PROJECT ID NO. SWQ0000005

**MONTEITH PARK AND VIEW PARK
GREEN ALLEY STORMWATER IMPROVEMENTS**

NOTICE INVITING BIDS

DR-10

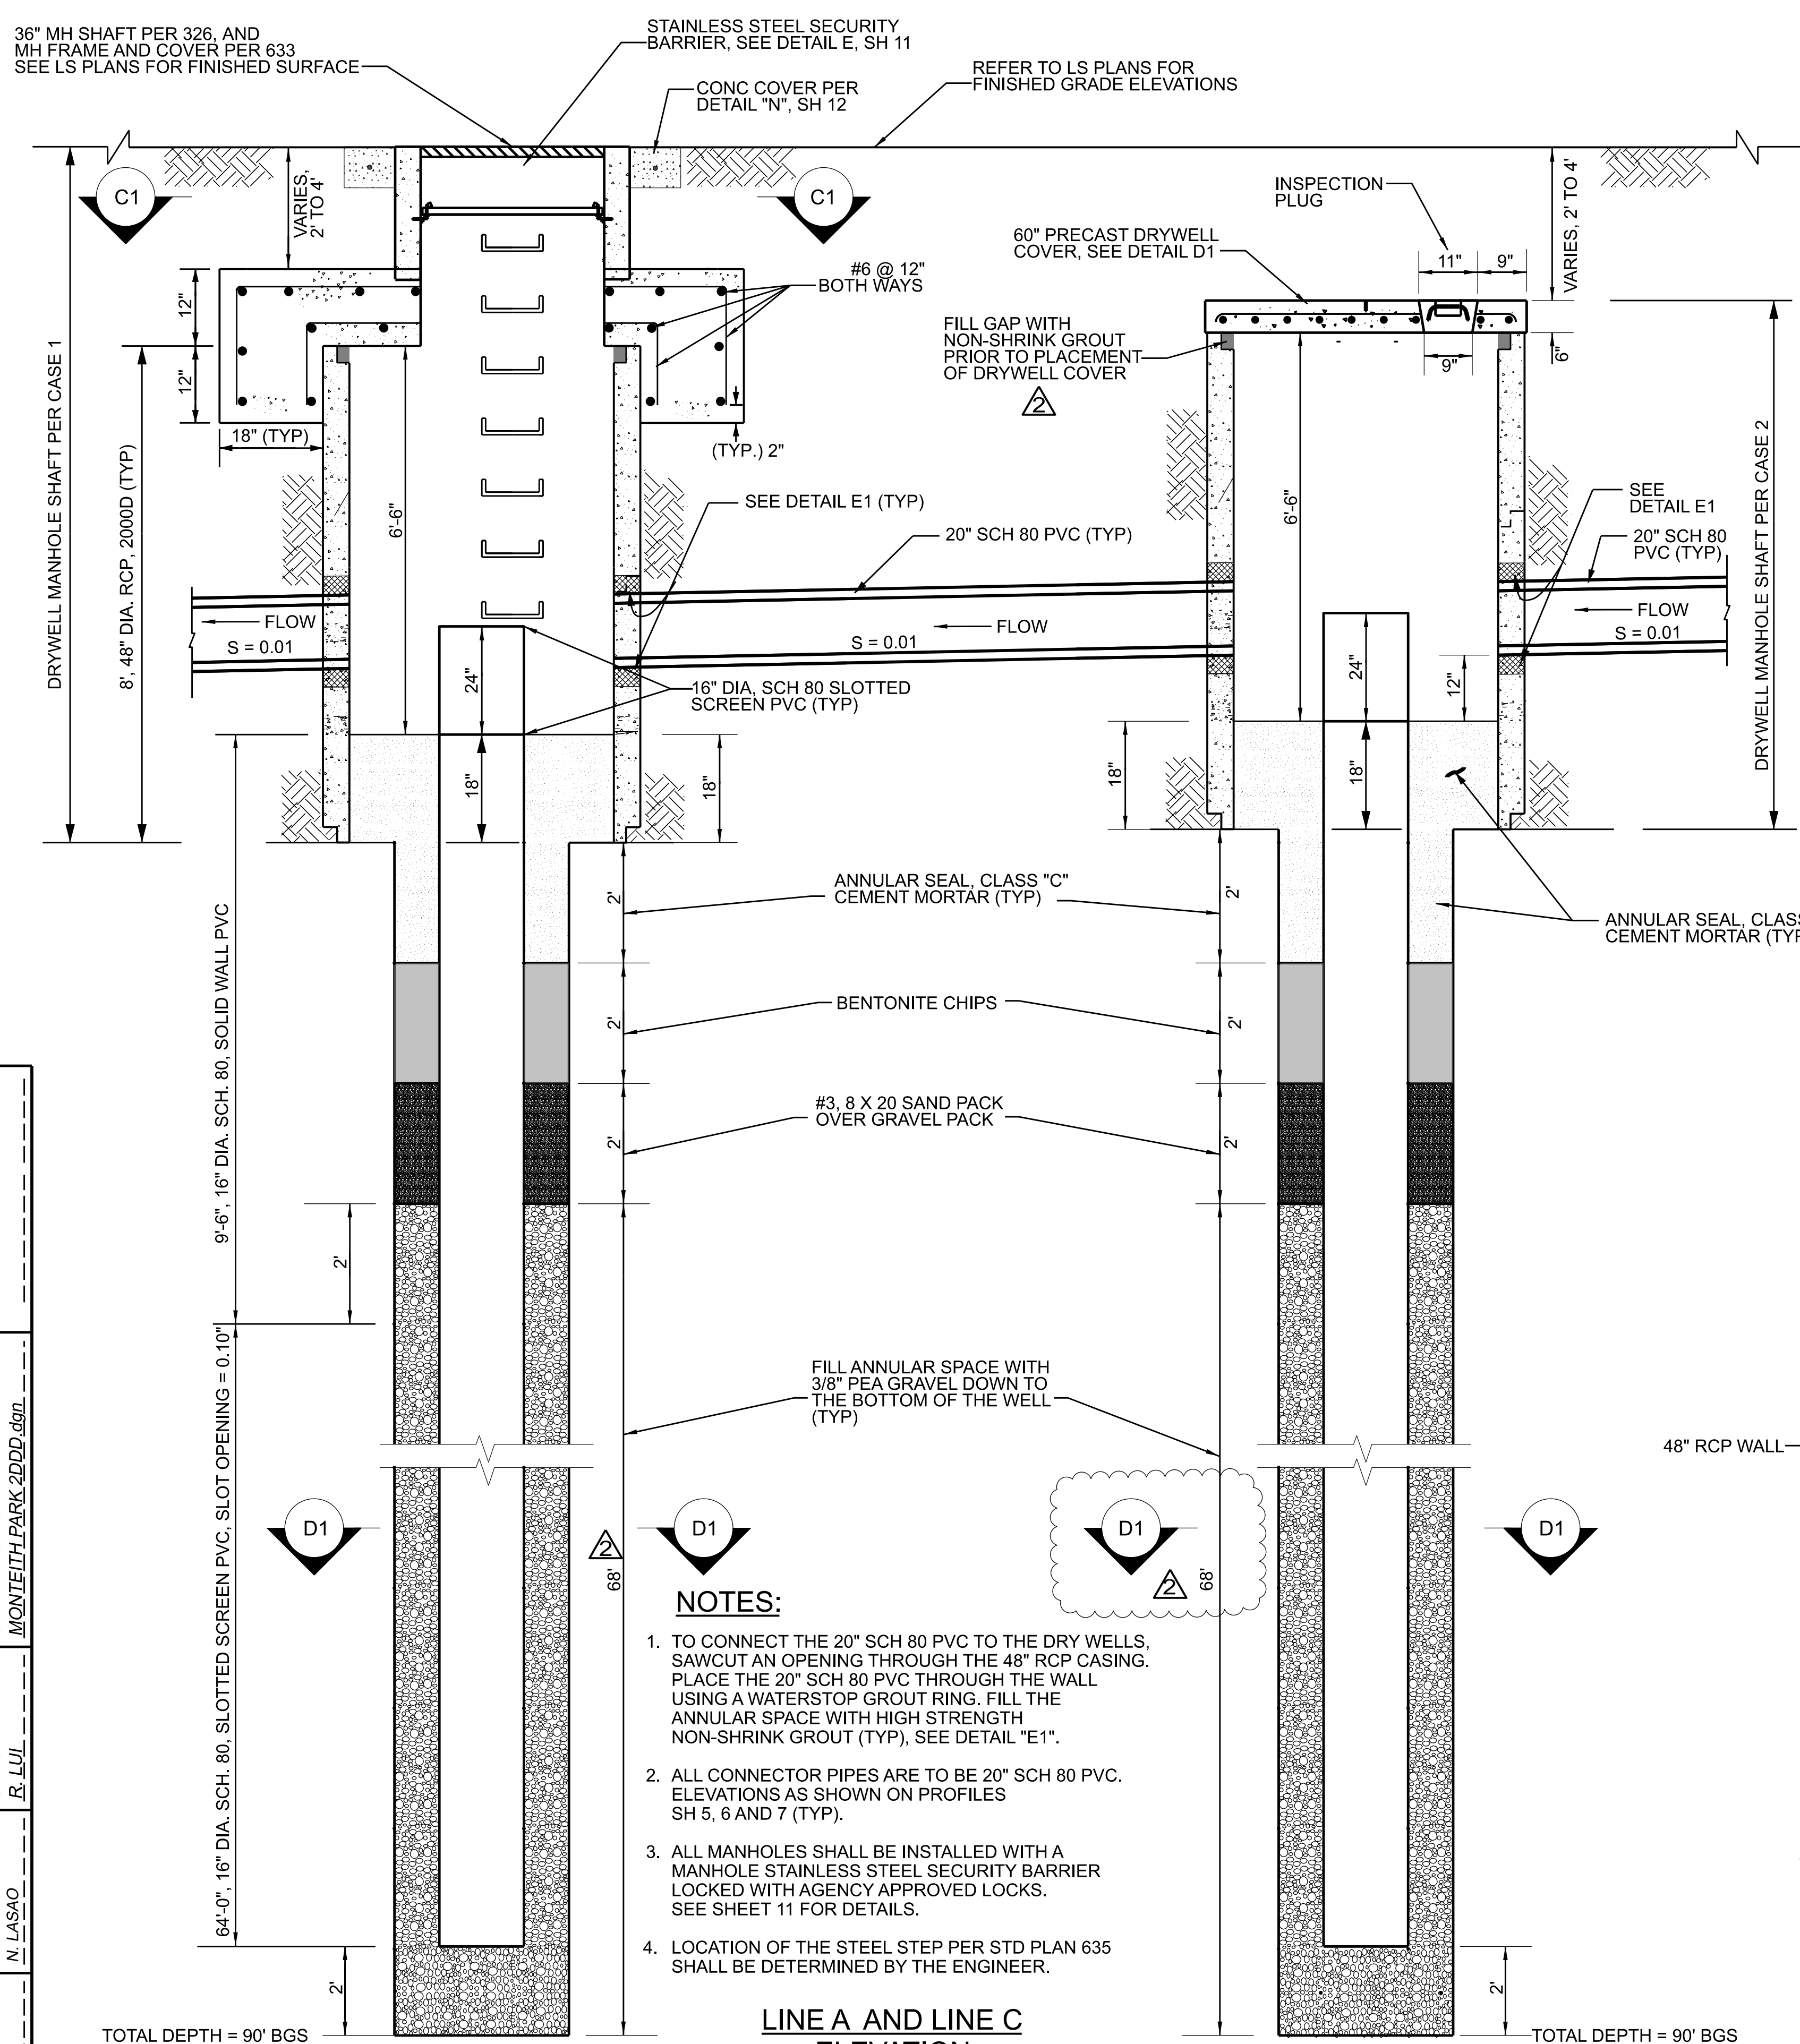
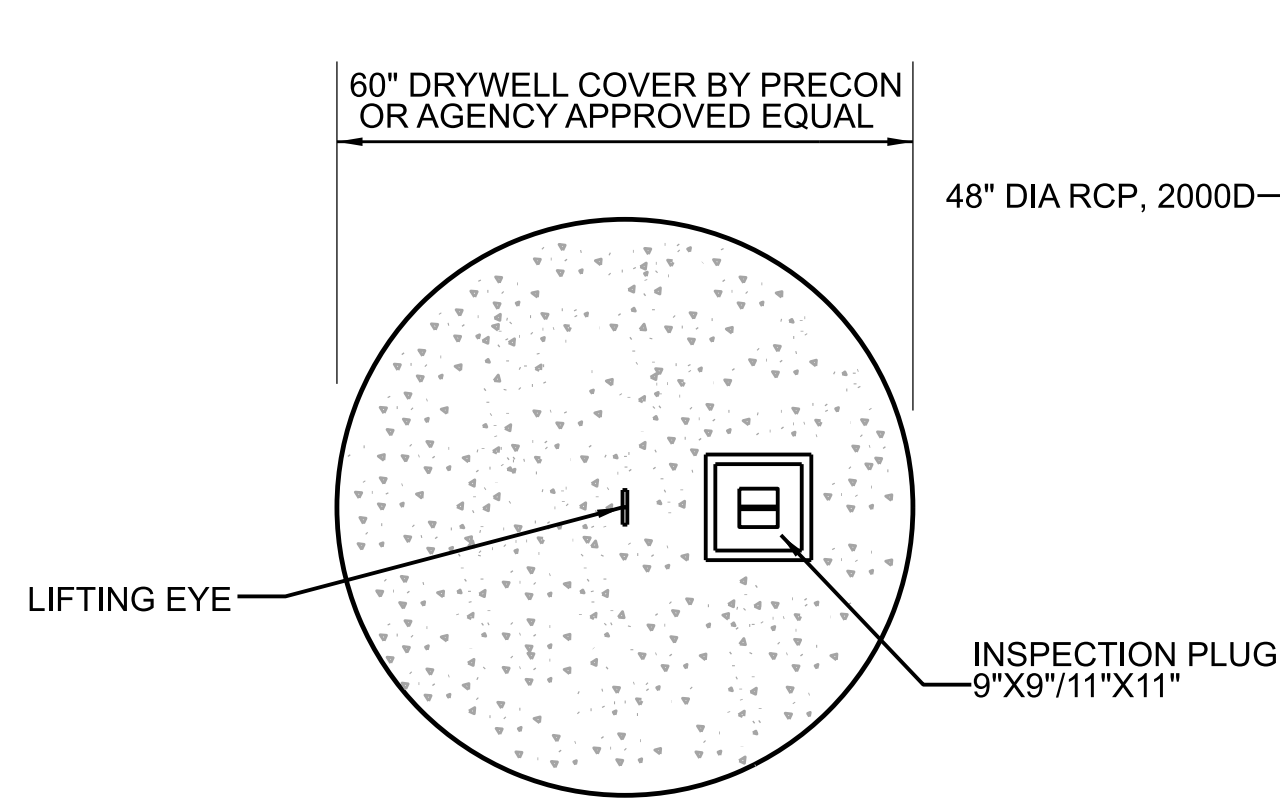
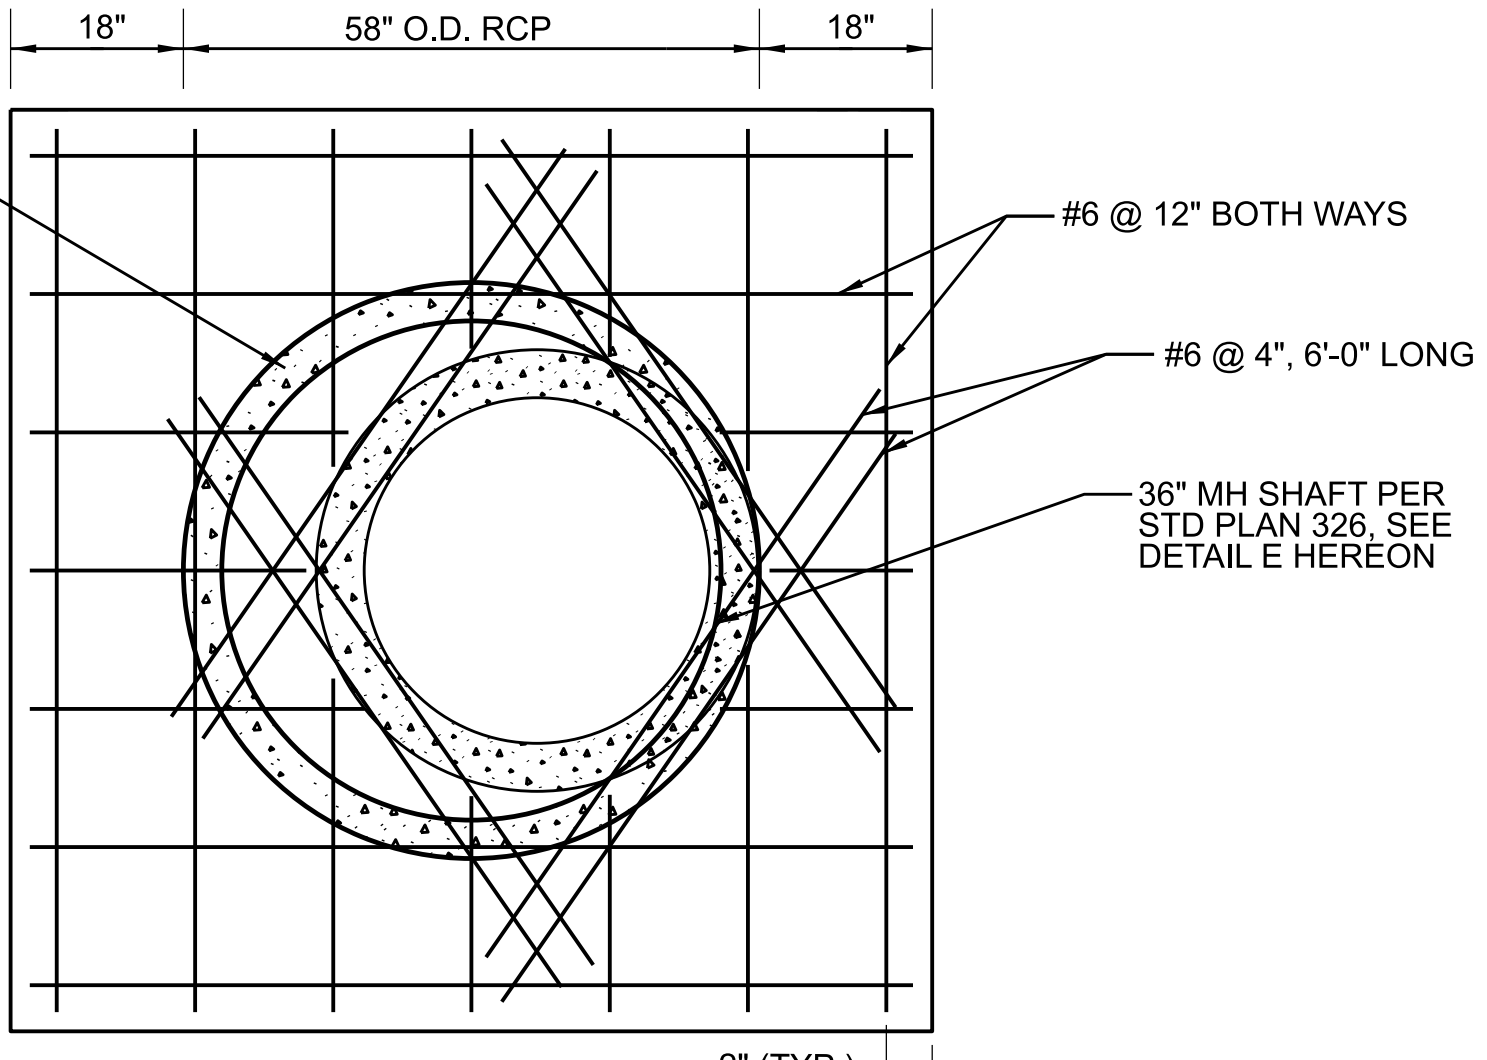
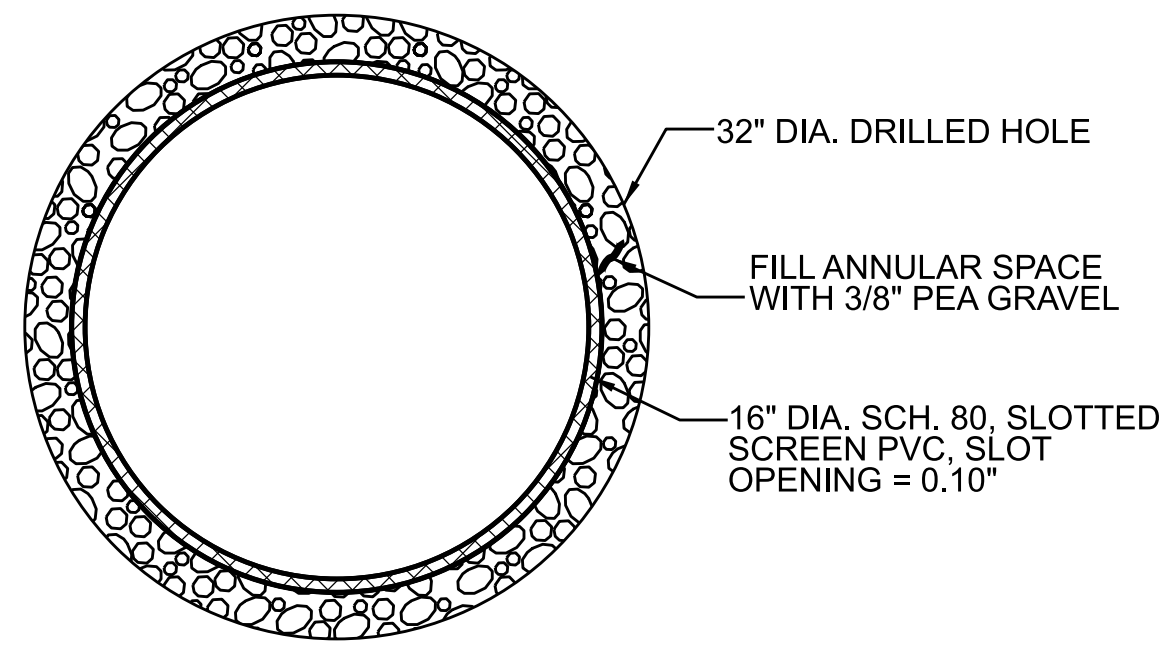
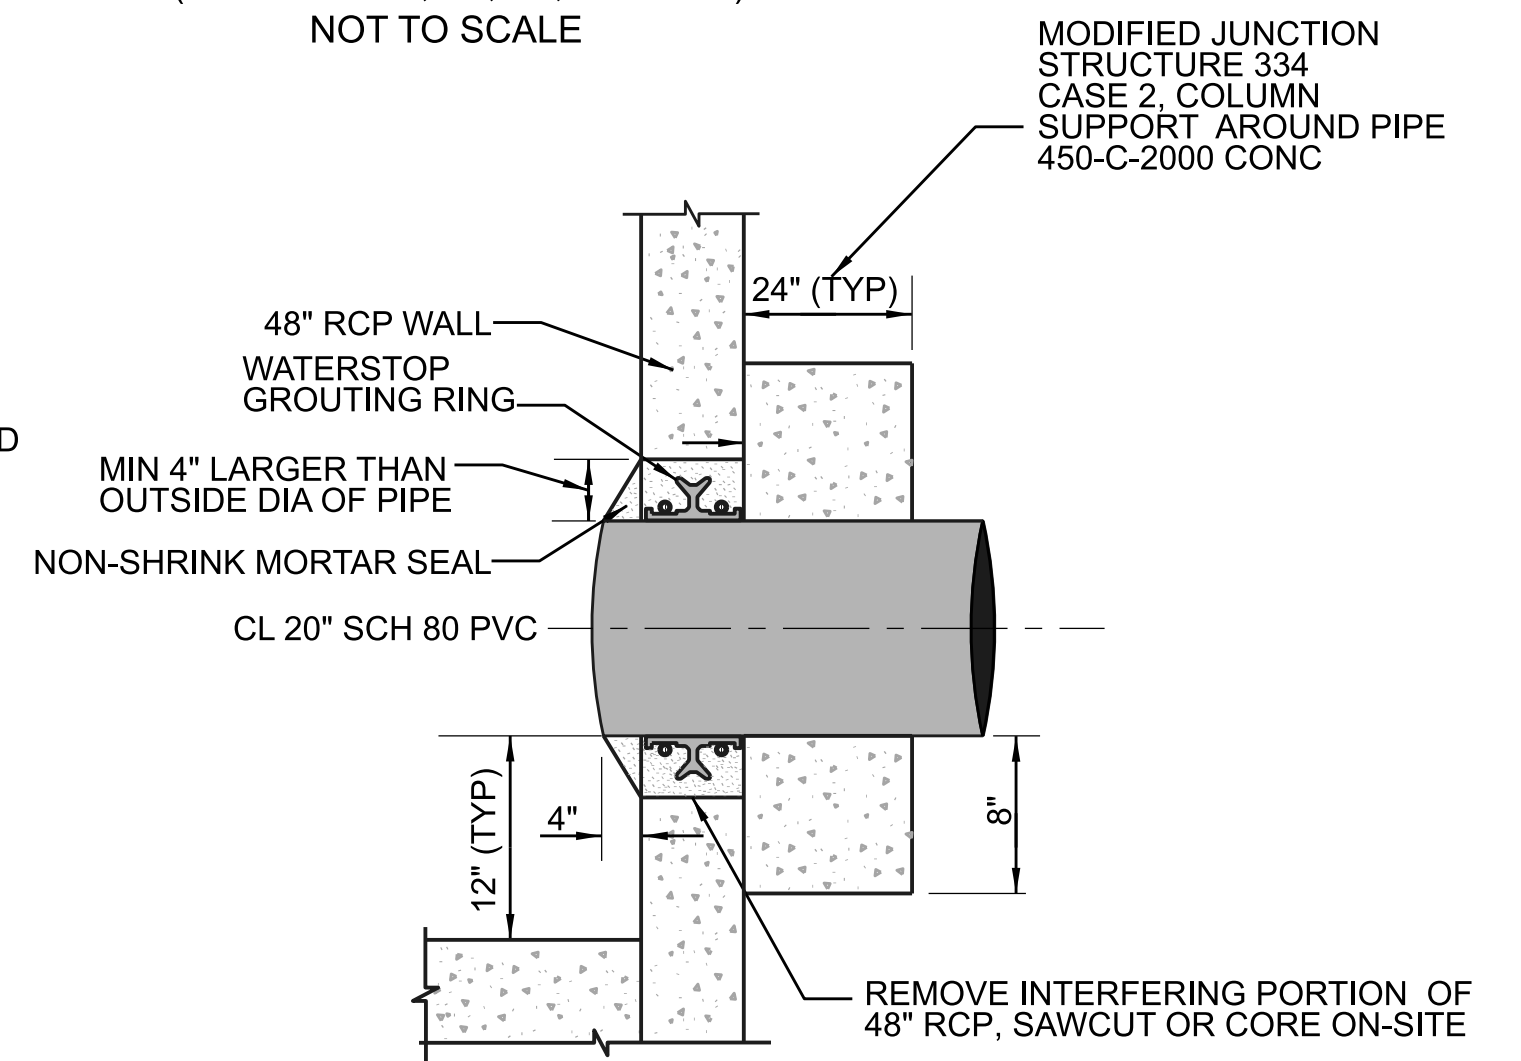
- *Sheet DR-8 (sheet 8 of 70) – Revision 4 – added right-of-way dimensions*
- *Sheet DR-9 (sheet 9 of 70) – Revision 3 – added right-of-way lines and dimensions*
- *Sheet DR-10 (sheet 10 of 70) – Revision 2 – changed depth from 78' to 68', changed label*
- *Sheet DR-14 (sheet 14 of 70) – Revision 1 – changed inflow and outflow pipe from 24" RCP to 20" PVC*
